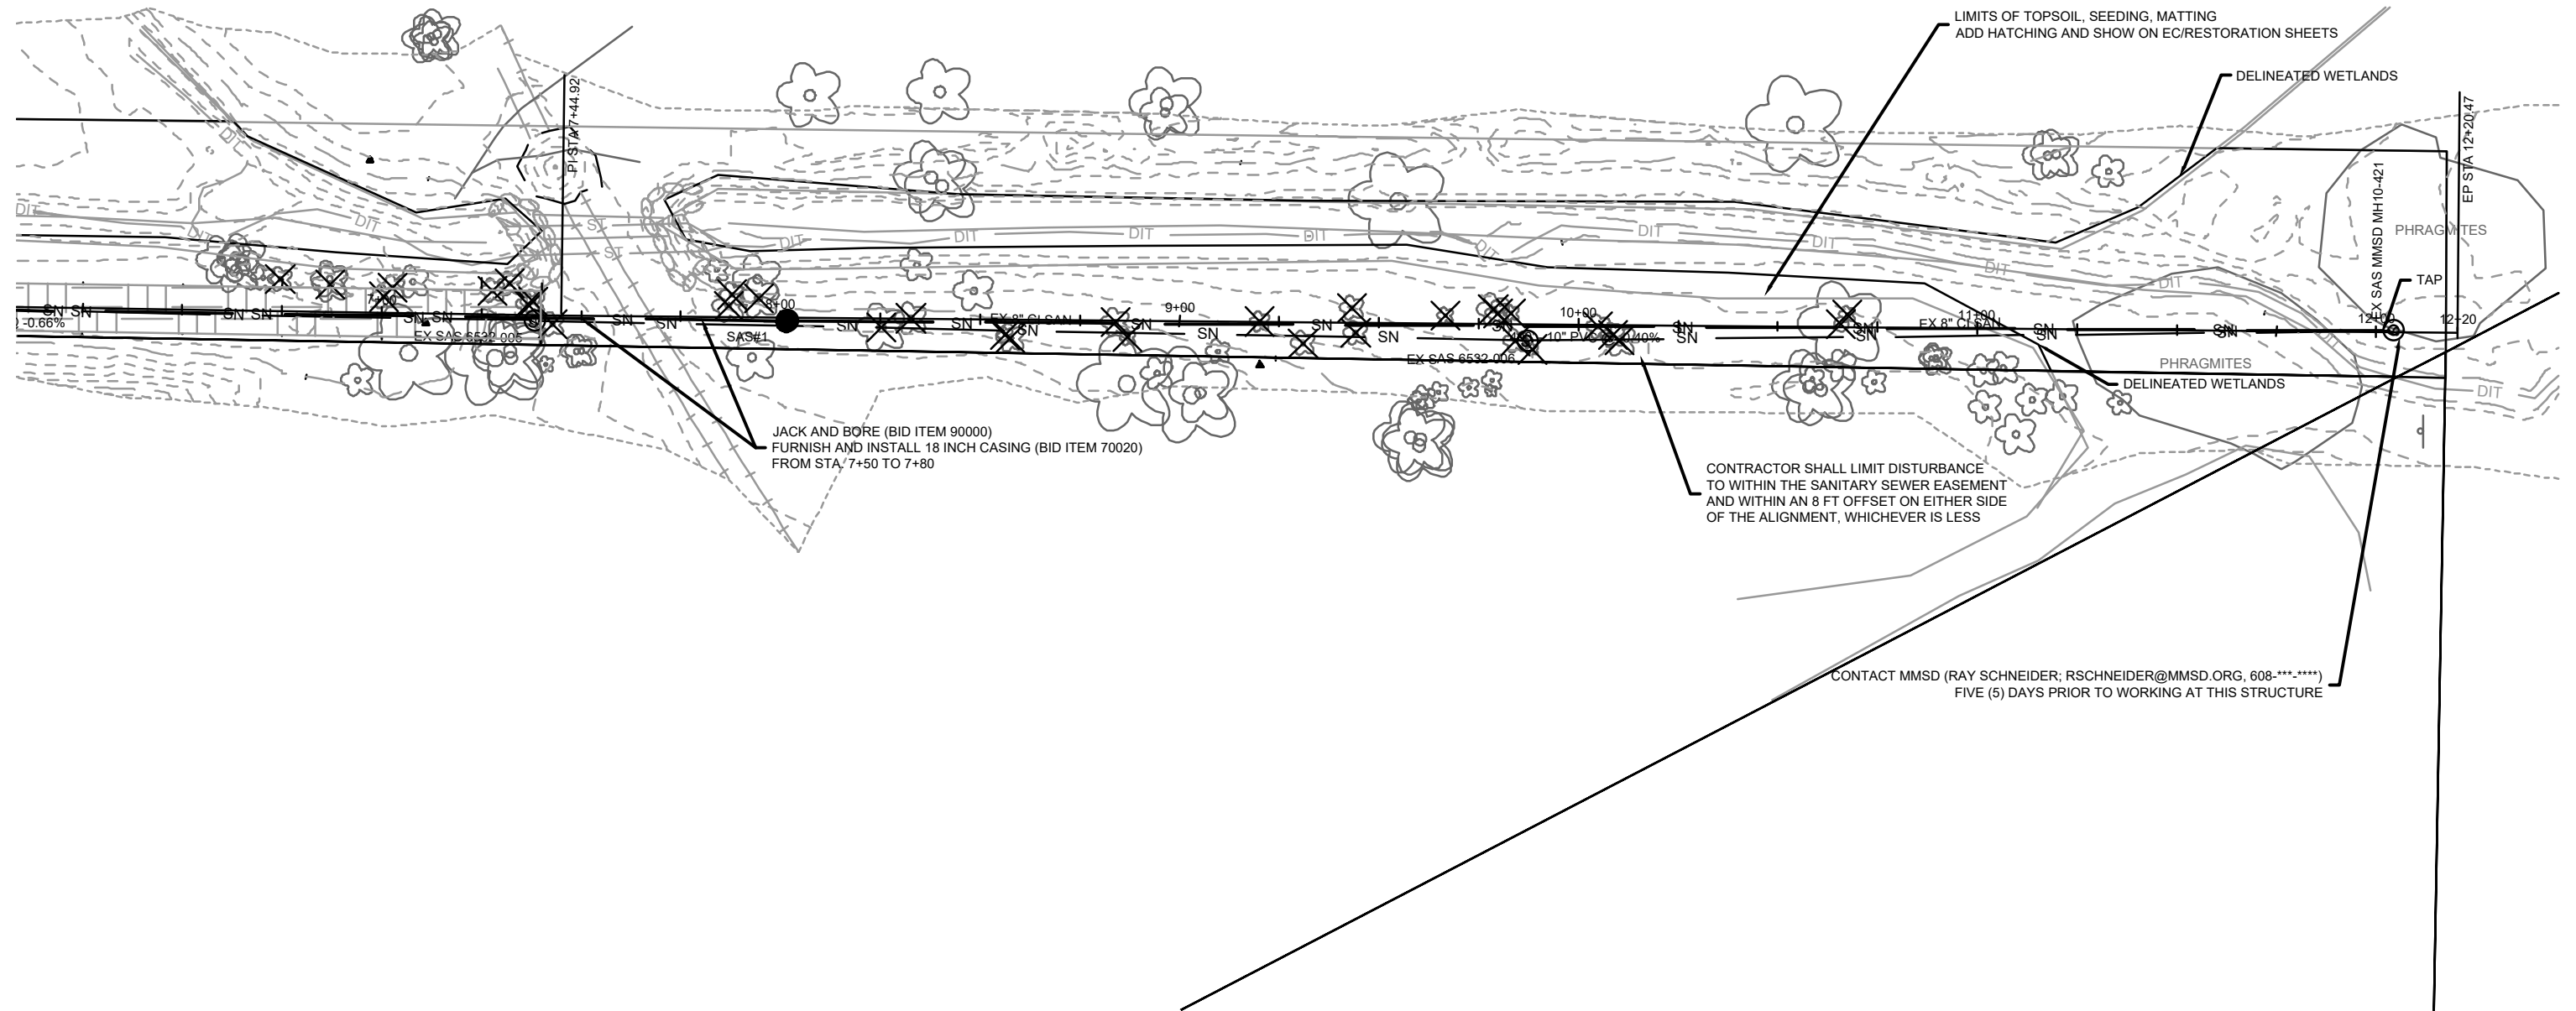
LIMITS OF TOPSOIL, SEEDING, MATTING (LAYER C-EROS)
ADD HATCHING AND SHOW ON EC/RESTORATION SHEETS

LIMITS OF TOPSOIL, SEEDING, MATTING
 ADD HATCHING AND SHOW ON EC/RESTORATION SHEETS
